SERVICE BULLETIN M20-295A

Date: September 17, 2007

SUBJECT: Aircraft with Garmin GFC700 – Manual Electric Trim and Roll Servo Installation.

Figure SB M20-295-1 - Control Wheel Harness Connector

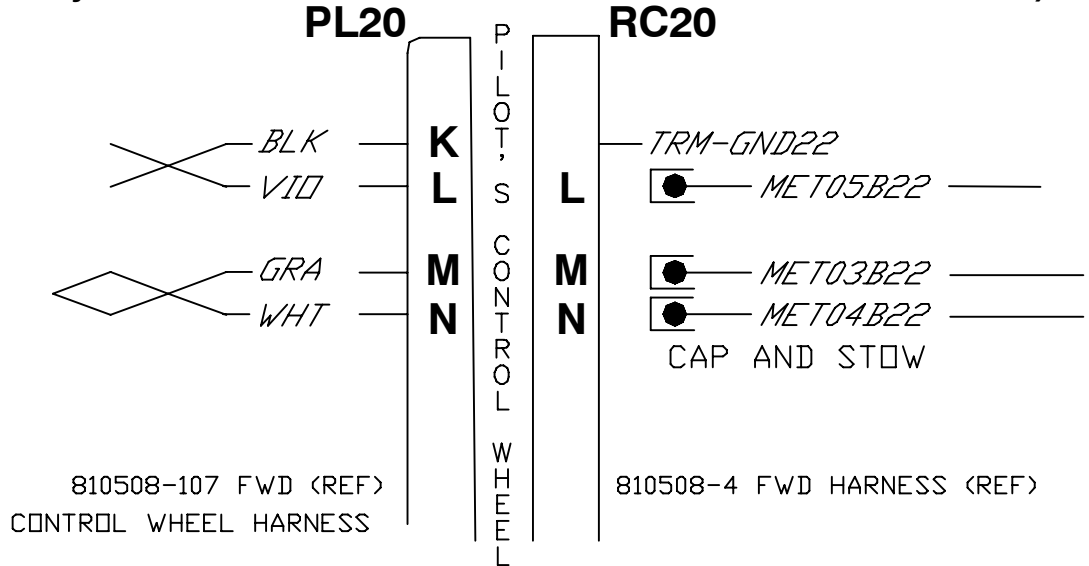
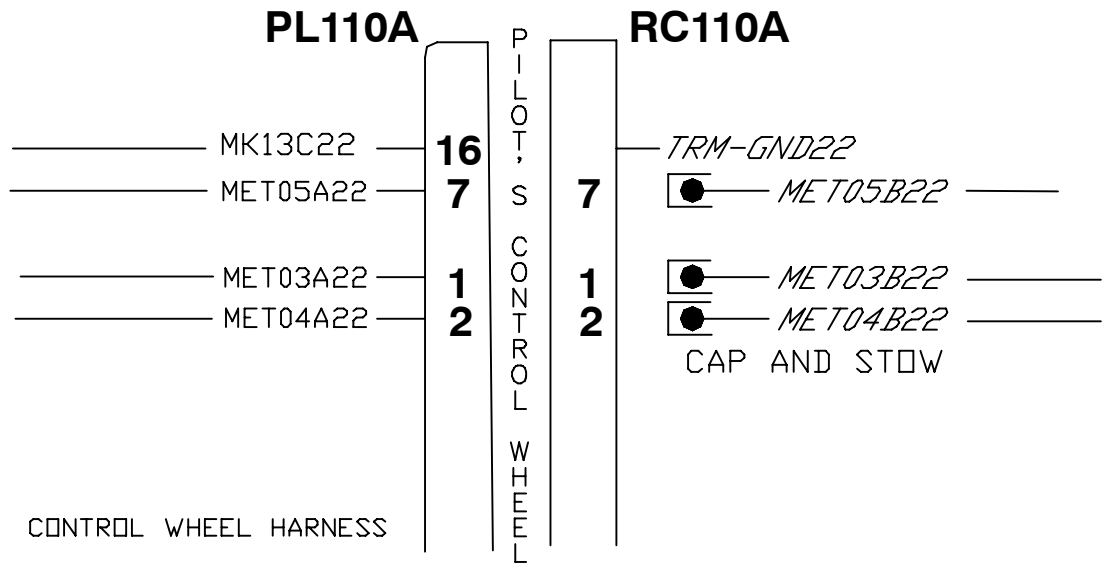
- 1-1. Turn master switch - OFF.
- 1-2. Locate AMP connector with specified wires at end of the Pilot's Control Wheel tube, verify if factory installed or retrofit installed (see Figure 1) also refer to Chapter 39-10-04 of applicable MAC aircraft Service & Maintenance Manual.

- 1-3. Remove specified wire pins (Aircraft side of harness) with an AMP Extractor Tool (AMP P/N 305183), cap wires individually with 3” of PVC Tubing (P/N RM026215). Stow and secure wires using (2) cable ties (P/N T50R9M4) on the Pilot's Control Wheel harness (see Figure 1 and 2) also refer to Chapter 39-10-04 of applicable MAC aircraft Service & Maintenance Manual.
- 1-4. Install any cable ties to secure harness if removed for access.
- 1-5. Install placard (P/N 150056-(X)3048(Y)) on instrument panel (see Figure 3), clean surface area with isopropyl alcohol before applying placard to remove any oils or debris.

(Factory Installed GFC700 - Color Coded Trim Switch Harness)

(Retrofit Installed GFC700 - Wire Numbered Trim Switch Harness)

Figure SB M20-295-4 - GFC700 Roll Servo Adjustment

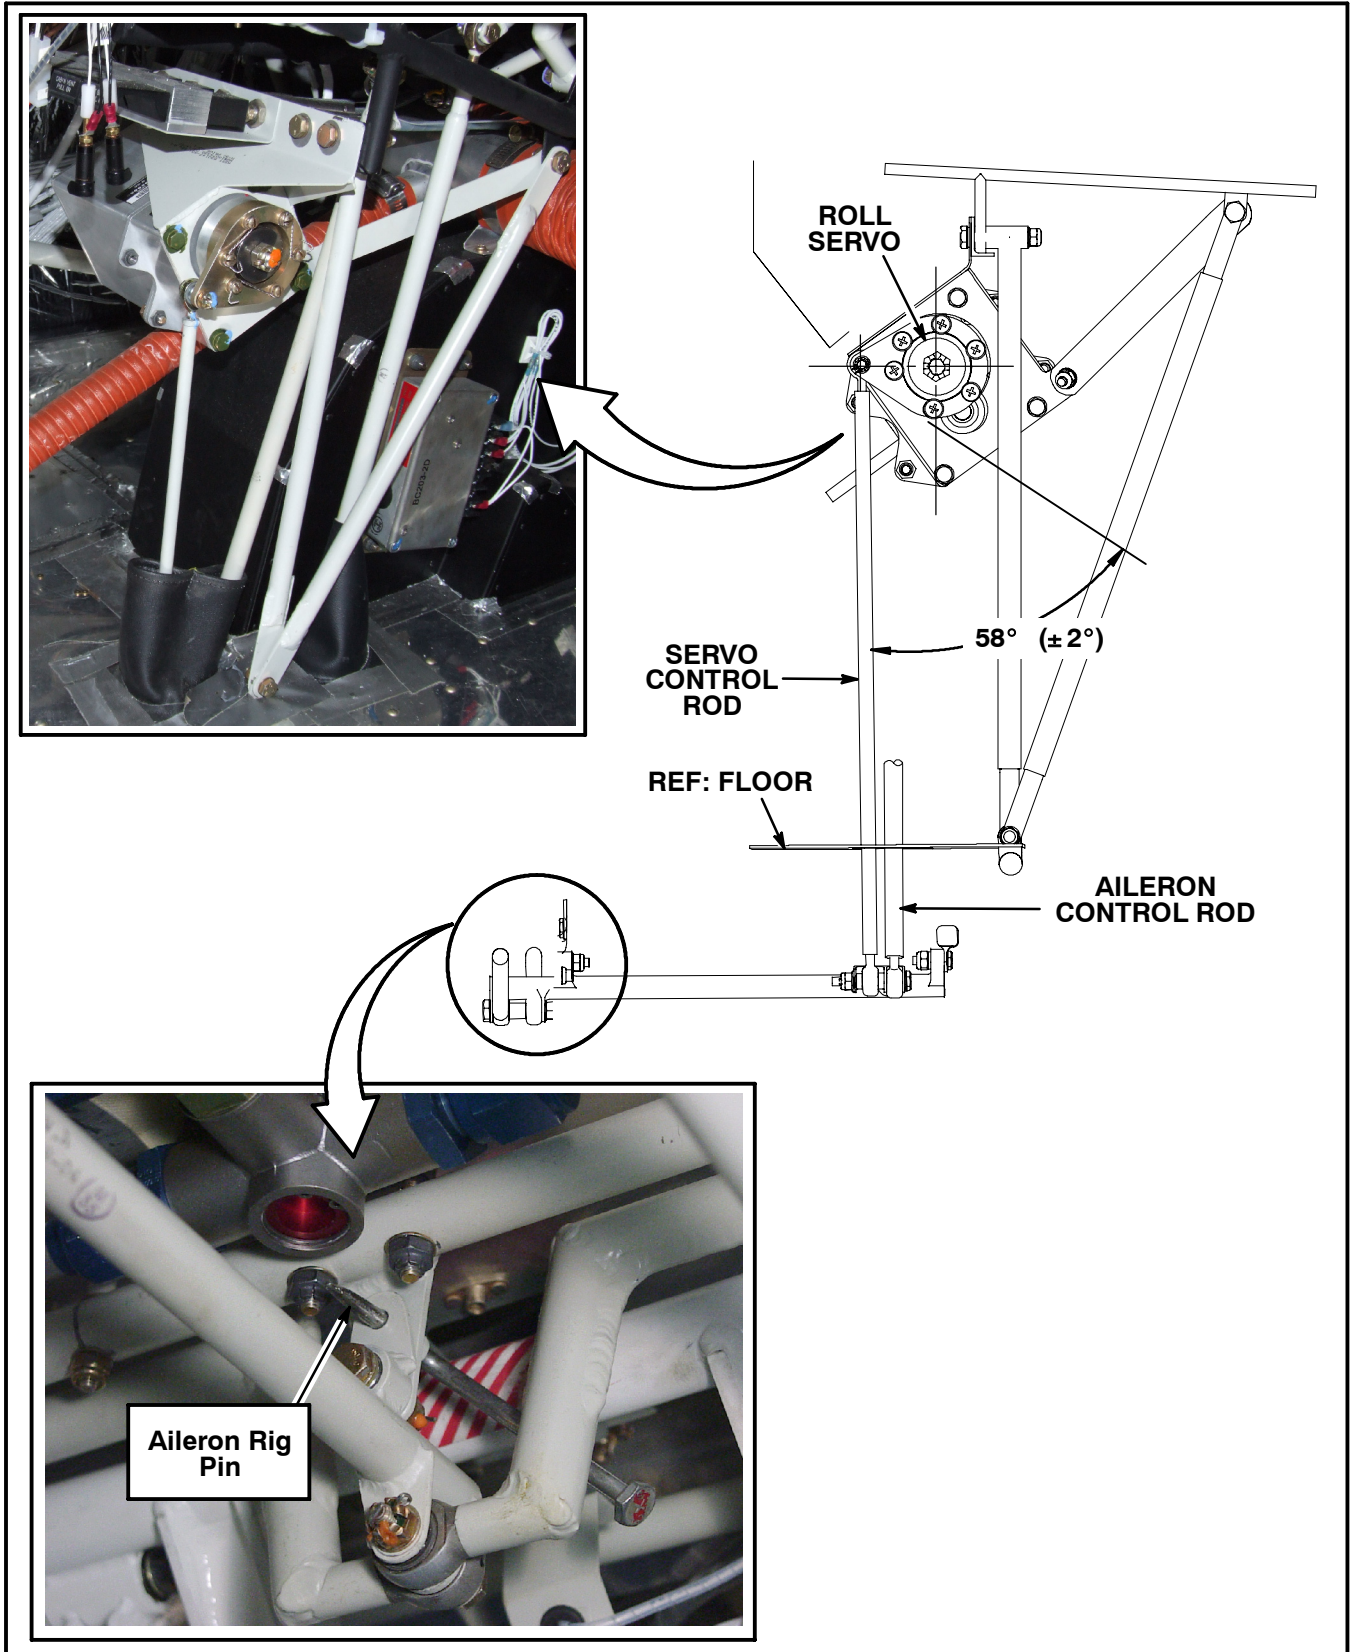
Procedure 2: There are two control rods connecting the aileron control linkage, which are sensitive to the order in which they are “adjusted”. We have experienced at least one instance where the mechanic did not realize they were order dependant. Occasionally the aileron control rod is adjusted to center the “cushion”. When this is done post GFC 700 installation, the servo control rod must be readjusted to center the servo arm.

- 2-1. Remove the forward belly fairing.
- 2-2. Insert aileron rig pin (see Figure 4)
- 2-3. Remove the middle panel of the center console to access roll servo.
- 2-4. Use an alignment tool (or protractor) to check the 58° (± 2°) required alignment (see Figure 4).
- 2-5. If the alignment is unsatisfactory, adjust rod end on the servo control rod as needed (lengthen or shorten) to obtain the proper 58° (± 2°) alignment (see Figure 4) also refer to Chapter 27-10-00 of applicable MAC aircraft Service & Maintenance Manual for Aileron Rigging.

This alignment should be performed every time the aileron control tube is adjusted.
